# Access Audit Site Report

**Copper Breaks State Park  
777 State Hwy Park Rd 62  
Quanah, TX 79252**

**Accessibility Evaluation  
Inspection Date: 05/18/2022  
Inspectors: Tanya Scheibe**

**TEXAS PARKS AND WILDLIFE DEPARTMENT  
COPPER BREAKS STATE PARK**

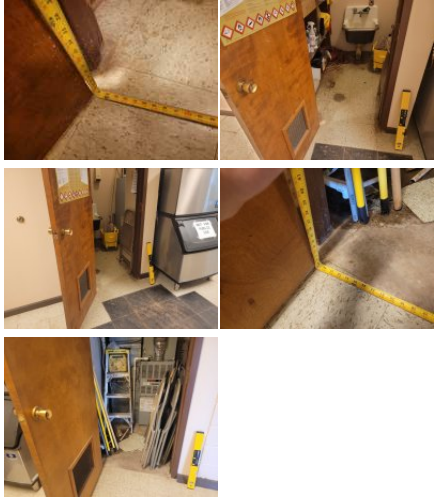
10	Headquarters Area: HQ - Public Spaces	[34.11221, -99.743255 1]	The threshold has a vertical change greater than 1/4 inch high. All interior doors must be maintained so that the operating pressure does not exceed 5 lb. force to open. The sweep period for doors with closers shall be adjusted so that from an open position of 70 degrees, the door will take at least 3 seconds to move to a point 3 inches from the latch, measured to the leading edge of the door. The bottom 10 inches on the push side must be smooth and free of obstructions (hold open devices). Opening hardware must be mounted between 30 and 44 inches above the floor or ground.	Entry interior- 11 lbf, 9 lbf, one door closes fast, 1" CIL at threshold, glass starts 4.5" AFF	For all doors along the public circulation route, repair, bevel, or ramp CILs at door entries to max .25". For all doors along the public circulation route, inspect, adjust, and maintain 5 lbf to open interior doors. For all doors along the public circulation route, inspect, adjust, and maintain closing speed on door closers. For all doors along the public circulation route, provide kick plate on push side of door from floor to 10" AFF.	2010 ADAS Section: 404.2.3, 404.2.7, 404.2.4, 404.2.11, 404.2.11 Exception

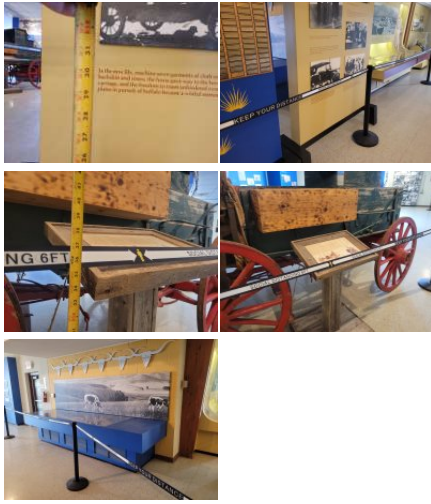
12	Headquarters Area: HQ - Public Spaces	[34.1121906 , -99.743233 5]	The transaction counter is too high. A portion of the counter surface that is 36 inches long minimum and 36 inches high maximum above the finish floor shall be provided. Knee and toe space must be provided for a forward approach. A 30 inch by 48 inch clear floor space on an accessible route must be provided for either a forward or parallel approach.	Service counter 42" AFF	Lower 36" wide segment of service counter to max 36" AFF.	2015 ABAAS Section: 904.4.2, 904.4.1  2012 TAS Section: 904.4.1, 904.4.2  2010 ADAS Section: 904.4.2, 904.4.1

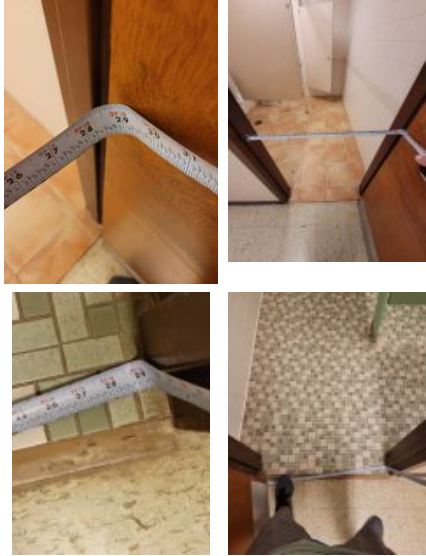
Finding Number	Area Description	Lat/Long	Finding	As Built	Recommendation	Citation	Photos	Figure
25	Headquarters Area: HQ - Men's Restroom	[34.1122061, -99.7432416]	The water and drain pipes under the lavatory are not adequately insulated. Water supply and drain pipes under lavatories and sinks shall be insulated or otherwise configured to protect against contact. There shall be no sharp or abrasive surfaces under lavatories and sinks.	pipes lack insulation	Insulate exposed pipes under one sink.	2015 ABAAS Section: 606.5 2012 TAS Section: 606.5 2010 ADAS Section: 606.5		
26	Headquarters Area: HQ - Men's Restroom	[34.1121884, -99.7432496]	Where a high forward reach is over an obstruction, the clear floor space shall extend beneath the element for a distance not less than the required reach depth over the obstruction. The high forward reach shall be 48 inches (1220 mm) maximum where the reach depth is 20 inches (510 mm) maximum. Where the reach depth exceeds 20 inches (510 mm), the high forward reach shall be 44 inches (1120 mm) maximum and the reach depth shall be 25 inches (635 mm) maximum. Where a clear floor or ground space allows a parallel approach to an element and the high side reach is over an obstruction, the height of the obstruction shall be 34 inches (865 mm) maximum and the depth of the obstruction shall be 24 inches (610 mm) maximum. The high side reach shall be 48 inches (1220 mm) maximum for a reach depth of 10 inches (255 mm) maximum. Where the reach depth exceeds 10 inches (255 mm), the high side reach shall be 46 inches (1170 mm) maximum for a reach depth of 24 inches (610 mm) maximum.	Light switch 56.5" AFF	Lower operating mechanisms to max 48" above the finished floor (AFF) to highest operable part.	2015 ABAAS Section: 308.2.1, 308.3.2 2012 TAS Section: 308.2.1, 308.3.2 2010 ADAS Section: 308.2.1, 308.3.2

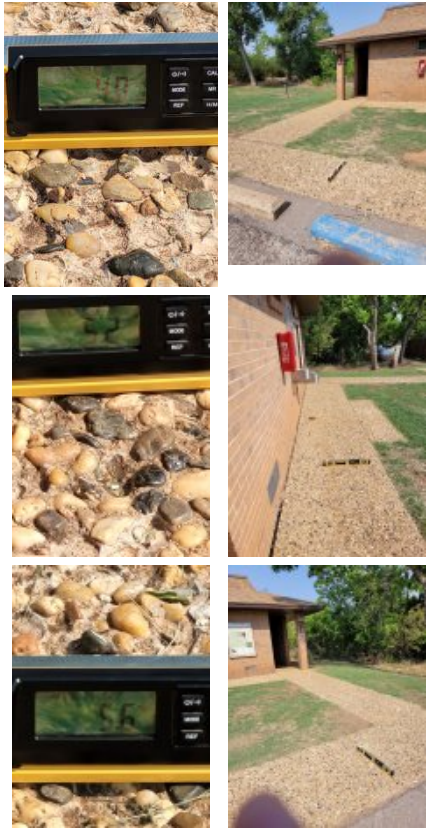
50	Kiowa Camping Area: Kiowa - Campsites 26-36	[34.1133209 , -99.7491639]	48 inches (1220 mm) by 48 inches (1220 mm) on all usable sides of the fire ring, grill, fireplace, and woodstove Center the space on each usable side of the grill, fireplace, and woodstove	Lacks clear ground space at grill and fire ring	Provide required 48" clear ground space centered along usable side of fire ring, grill, fireplace, or woodstove as a smart practice.	2015 ABAAS Section: 1011.2

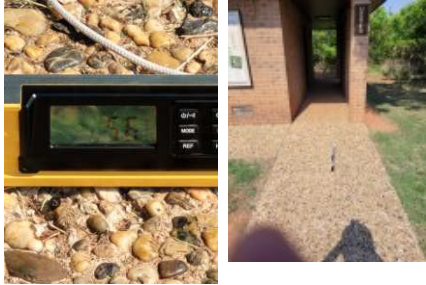
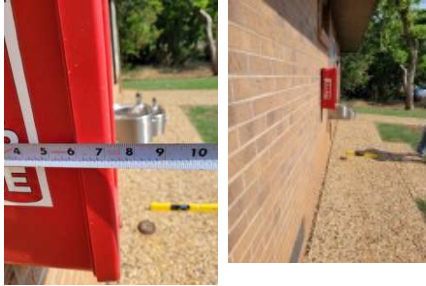
54	Kiowa Camping Area: Kiowa - Campsites 26-36	[34.113332, -99.7491639]	Parking spaces and pull-up spaces for recreational vehicles shall be 20 feet (6100 mm) wide minimum. EXCEPTION: Where two adjacent parking spaces are provided for recreational vehicles, one parking space shall be permitted to be 16 feet (4880 mm) wide minimum.	129" (10' 9") wide	Correct RV parking space to be 20' wide minimum; or 16' for two adjacent spaces as a smart practice.	2015 ABAAS Section: 1012.2, 1012.2 EXCEPTION	 	
55	Kiowa Camping Area: Kiowa - Campsites 26-36	[34.1133298, -99.7491558]	The surface of parking spaces and pull-up spaces shall be firm and stable. The slope of the surface of parking spaces and pull-up spaces shall not be steeper than 1:48 in any direction. EXCEPTION: Where the surface is other than asphalt, concrete, or boards, slopes not steeper than 1:20 shall be permitted when necessary for drainage.	2.8% slope	Correct surface of parking spaces to be firm and stable with slopes max of 2.08% or 5% for surfaces other than concrete, asphalt or boards as a smart practice.	2015 ABAAS Section: 1012.4, 1012.5, 1012.5 EXCEPTION

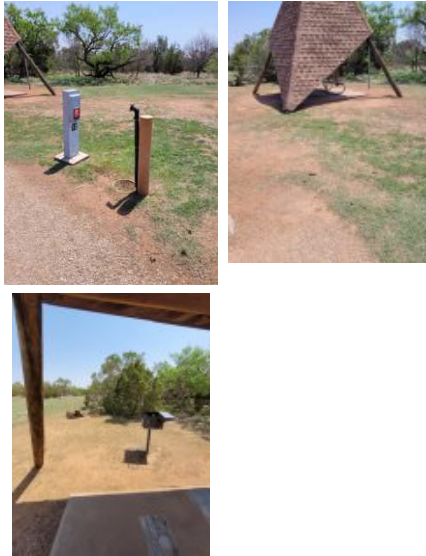
115	Cottonwood Group Campground: Cottonwood - Swimming	[34.1108688 , -99.748630 8]	Benches shall have a 36" by 48" clear ground space (CGS) positioned near the bench with one side of the space adjoining an outdoor recreation access route (ORAR) or trail, as applicable The CGS shall not overlap with the ORAR or trail or another CGS	0 of 4 benches comply, lacks ORAR to bench	Construct firm, stable, and slip resistant pads at least 36" by 48" adjacent to 20% of benches, and locate along an AR as a smart practice.	2015 ABAAS Section: 1011.2.1		
116	Cottonwood Group Campground: Cottonwood - Swimming	[34.1107078 , -99.748816]	Beach access routes shall connect an entry point to the beach to the: 1. High tide level at tidal beaches; 2. Mean high water level at river beaches; or 3. Normal recreation water level at lake, pond, and reservoir beaches	Lacks beach access route	Create a beach access route to normal recreational water level of a firm and stable material as a smart practice.	2015 ABAAS Section: 1018.2

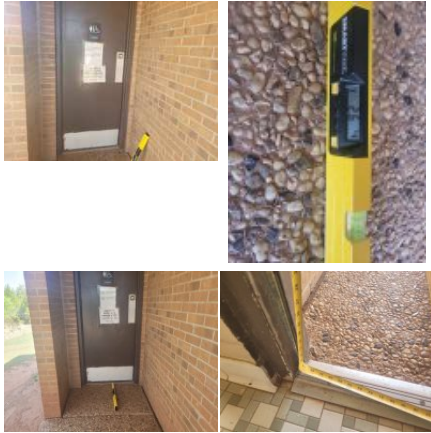
191	Big Pond Group Campground: Big Pond - Men's Restroom	[34.1177721 , -99.7558386]	The stall door fails to comply with all of the door requirements. The stall door must have compliant hardware on both sides. The stall door must be self-closing.	stall door not self-closing, lacks hardware on interior	Adjust stall door to be self-closing. Replace stall hardware with hardware operable without a tight pinch or grasp on both sides of the stall door.	2015 ABAAS Section: 404.2.3, 404.2.7, 604.8.2.2  2012 TAS Section: 404.2.3, 404.2.7, 604.8.2.2  2010 ADAS Section: 404.2.3, 404.2.7, 604.8.2.2

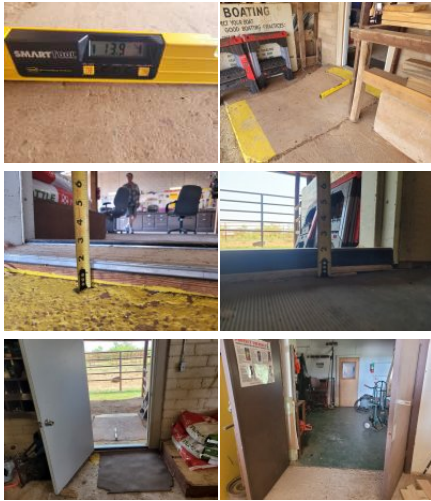
202	Big Pond Group Campground: Big Pond - Women's Restroom	[34.1177766 , -99.755843 9]	There are not enough accessible toilet compartments. The room contains toilet compartments. A minimum of 1 must be wheelchair accessible .	Ambulatory stall only	Create a wheelchair accessible stall with grab bars and fixtures mounted in correct locations and at correct heights.	2015 ABAAS Section: F213.3.1  2012 TAS Section: 213.3.1  2010 ADAS Section: 213.3.1
